Project	<b>IEEE 802.16 Broadband Wireless Access Working Group</b> < <a href="http://ieee802.org/16">http://ieee802.org/16</a> >
Title	<b>Combined figures 498 and 499</b>
Date Submitted	<b>2006-11-15</b>
Source(s)	Peretz Feder - Lucent Technologies <a href="mailto:pfeder@lucent.com">[mailto: pfeder@lucent.com]</a>
Re:	
Abstract	Combined Figures 498 and 499
Purpose	Adoption
Notice	This document has been prepared to assist IEEE 802.16. It is offered as a basis for discussion and is not binding on the contributing individual(s) or organization(s). The material in this document is subject to change in form and content after further study. The contributor(s) reserve(s) the right to add, amend or withdraw material contained herein.
Release	The contributor grants a free, irrevocable license to the IEEE to incorporate material contained in this contribution, and any modifications thereof, in the creation of an IEEE Standards publication; to copyright in the IEEE's name any IEEE Standards publication even though it may include portions of this contribution; and at the IEEE's sole discretion to permit others to reproduce in whole or in part the resulting IEEE Standards publication. The contr

**Figure 498 – Ranging Primitives (MS and BS)**

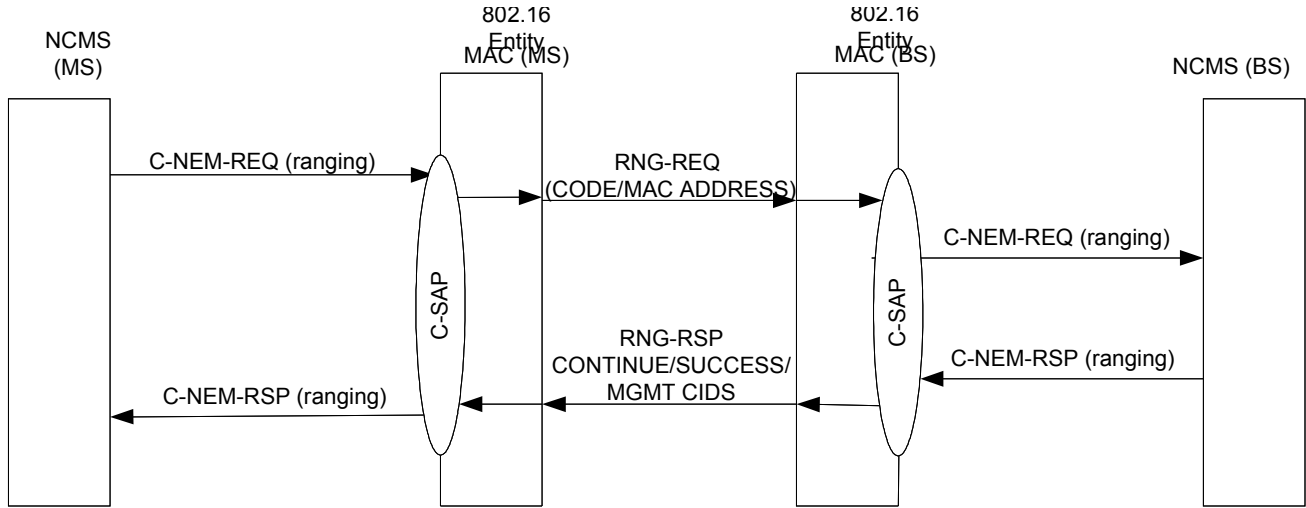
Ranging Primitivesm, present end-to-end view of Figures 498 and 499

In section 14.2.8, combine Figures 499 and 498 per below:

Reproduce in a format that shows end-to-end exchange of RNG-REQ and RNG-RSP between MS+NCMS and BS+NCMS
